HISTORIC AND DESIGN REVIEW COMMISSION June 19, 2019

HDRC CASE NO: 2019-332

COMMON NAME: ROW at 610 Augusta **ADDRESS:** 610 AUGUSTA

TYPE OF WORK: Installation of a new pole for network node equipment

ENLARGED SITE PLAN **\$ ANTENNA PLANS**

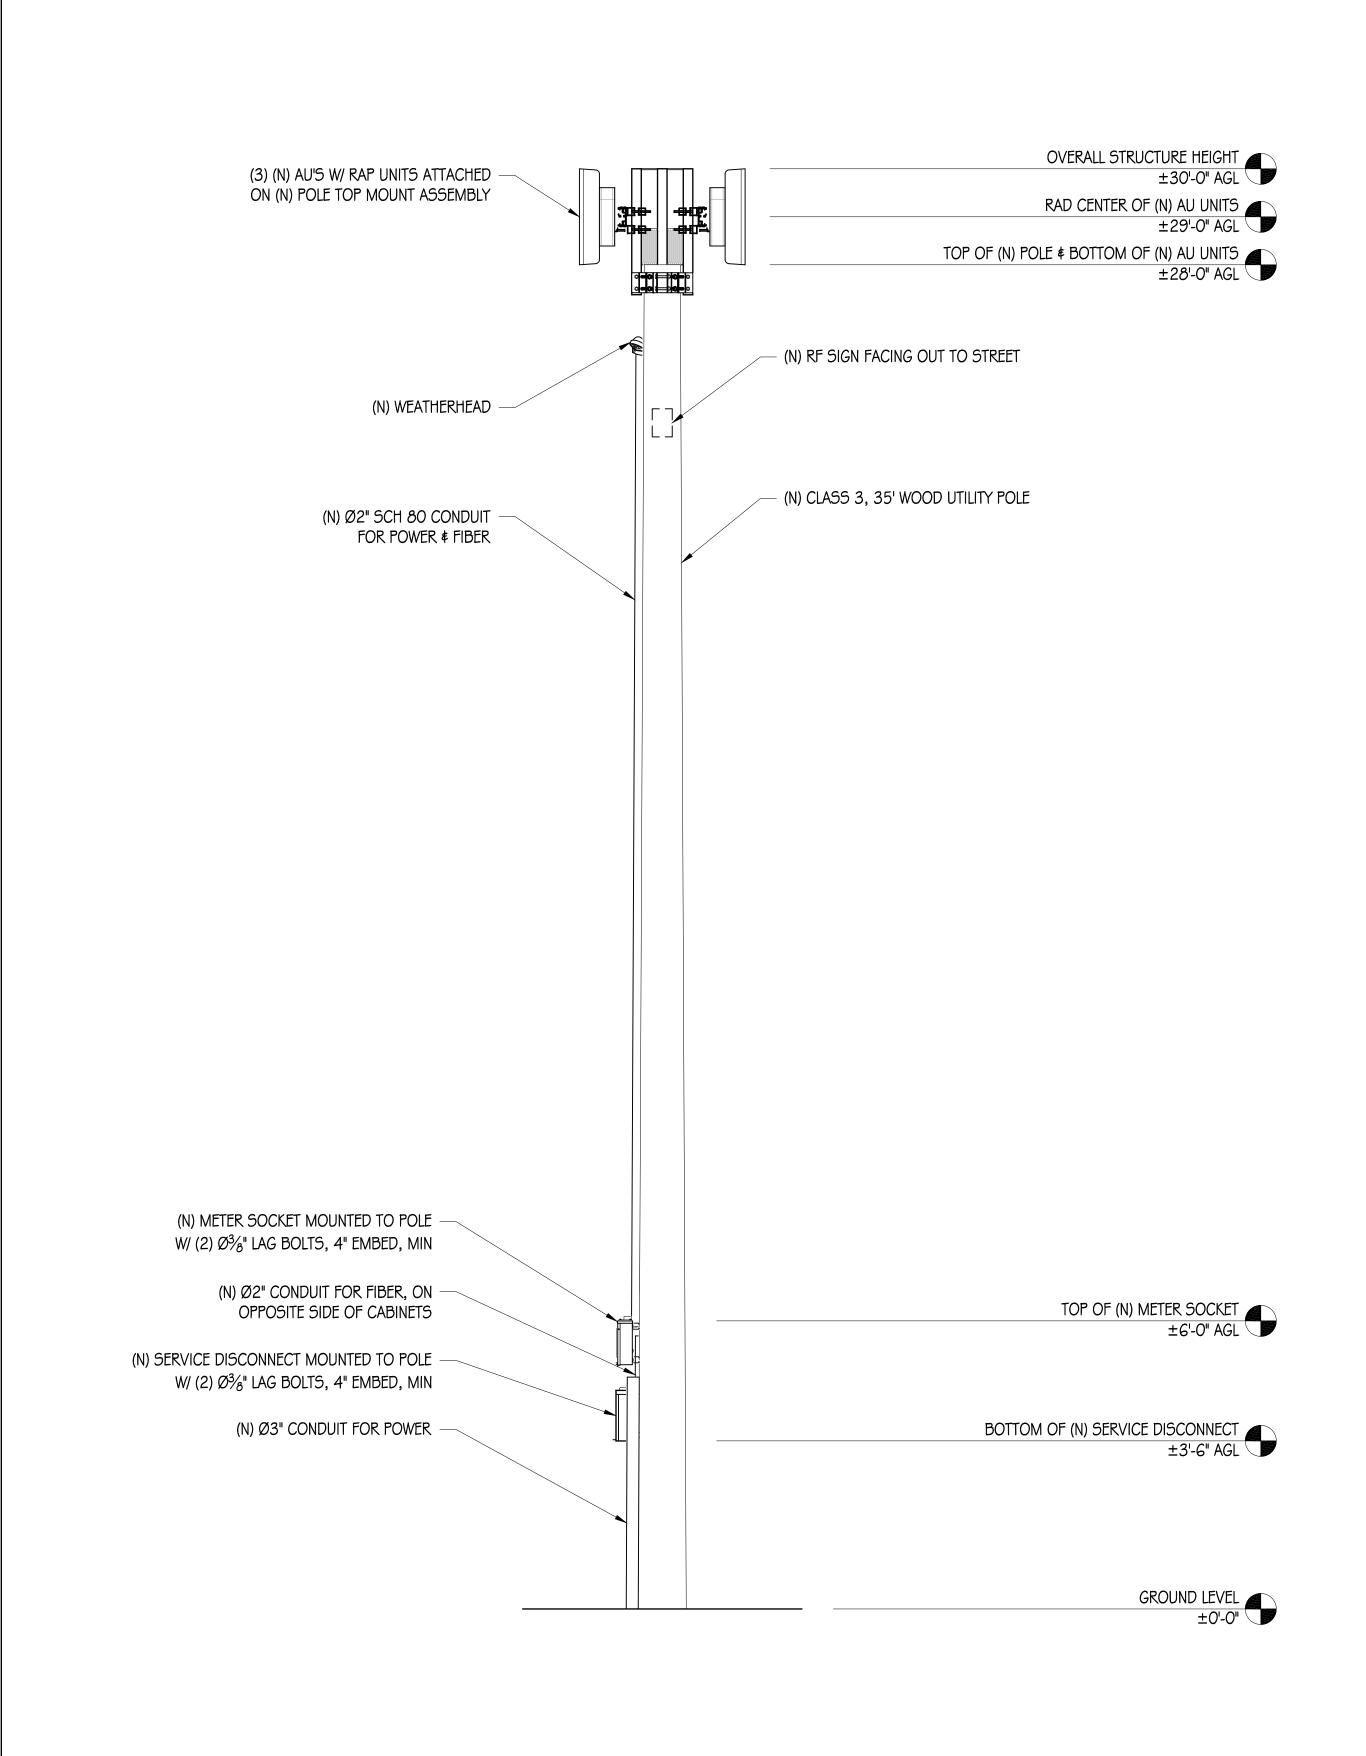
- d. LOCATION The applicant has proposed to install a new wood pole featuring network node equipment on the right-of-way at the eastern corner of the intersection at Augusta and Lexington, closest to the property at 610 Augusta (29.433227, -98.489897). Per the Design Manual 3.B.i., new poles must be generally located at commercial corners and intersections. While the applicant has made an effort to locate the pole at an intersection, staff finds that the pole would obstruct an existing primary signage area for the structure at 610 Augusta.

- e. SEPARATION The applicant has proposed to install the new pole within the immediate block as multiple existing utility poles. Per the Design Manual 3.B.ii., new poles must be separated from existing poles by 250 feet. Staff finds that the proposed location is not separated by more than 250 feet.

ELEVATIONS

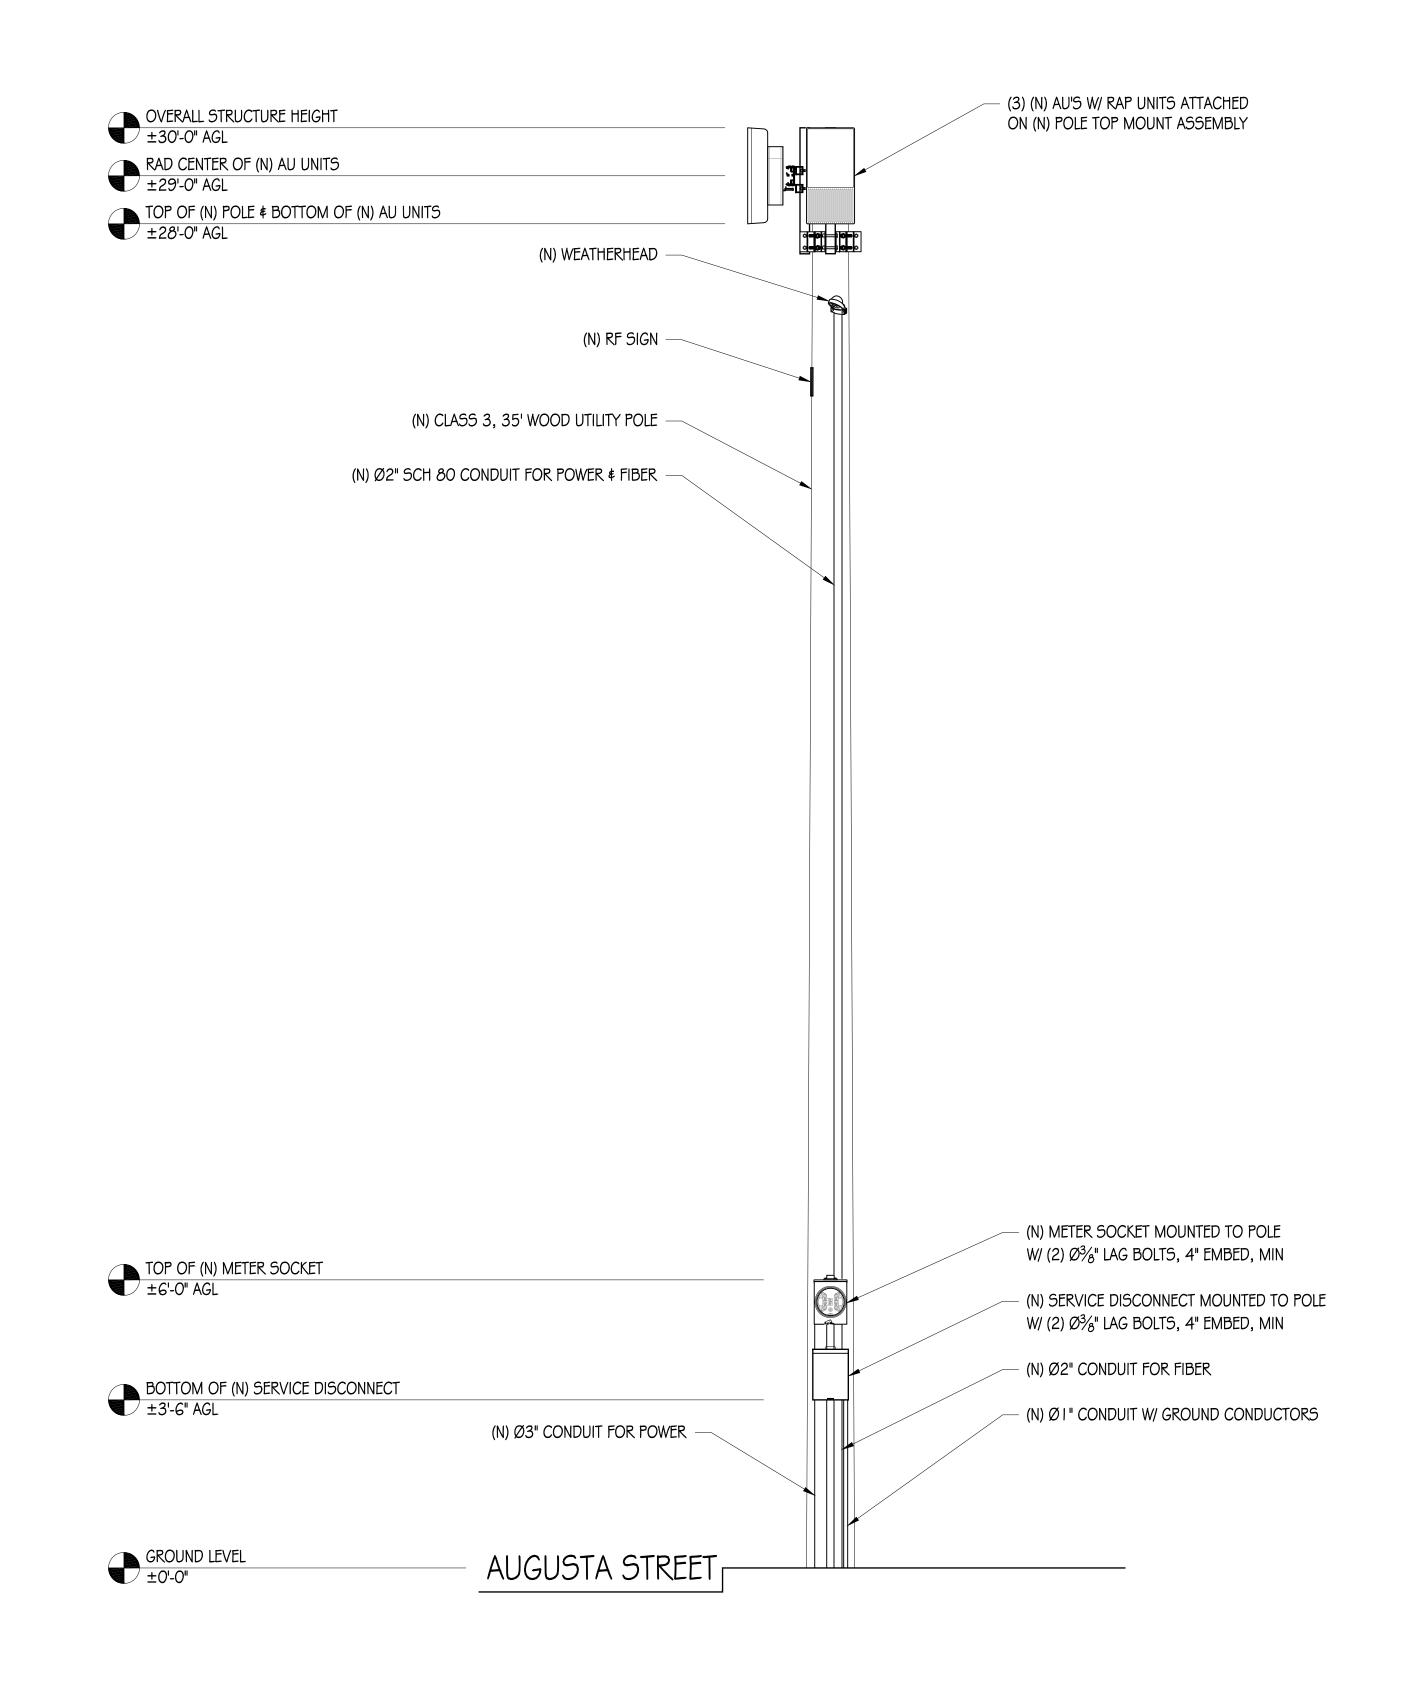
- g. HEIGHT The applicant has proposed to install a wood pole including node equipment featuring a total of thirty feet (30') from grade. Per the Design Manual 3.B.iv., the height of new node support poles should not exceed the established predominant height of other poles and historic site elements located within 500 feet of the proposed installation. Staff finds that the proposed height is subordinate to existing poles within proximity.

- h. DIAMETER The applicant has proposed to install a pole that is 32 inch (32") in diameter excluding the meter boxes at the pedestrian level and the antenna cabinets at the top. Per the Design Manual 3.B.v., new poles should not exceed 8 inches (8") in diameter at the widest portion of the pole. Staff finds that the proposed pole diameter

- is four times wider allowed by the design manual.
- i. DESIGN The applicant has proposed to install a wood pole with a meter socket (box), service disconnect (box) and linear conduit up to six feet (6') and three (3) au/rap units (grey cabinets) that are 11.4 inch wide, 14.6 inch tall, and extend no more than one feet (1') from the wood pole. The applicant referenced existing wood utility poles in selecting the pole type in this location. Per the Design Manual 3.B.: *The Historic Preservation Officer may require concealment of the support pole in the form of aesthetically appropriate street lamps, site elements, district signage, or other stealth methods. The color of any new support pole or concealment solution shall be determined by the Historic Preservation Officer based on site specific conditions.* Staff finds that no effort has been made to conceal or relate the proposed new pole to the existing context or site elements at N Mesquite except the use of a wood pole and matching equipment color.
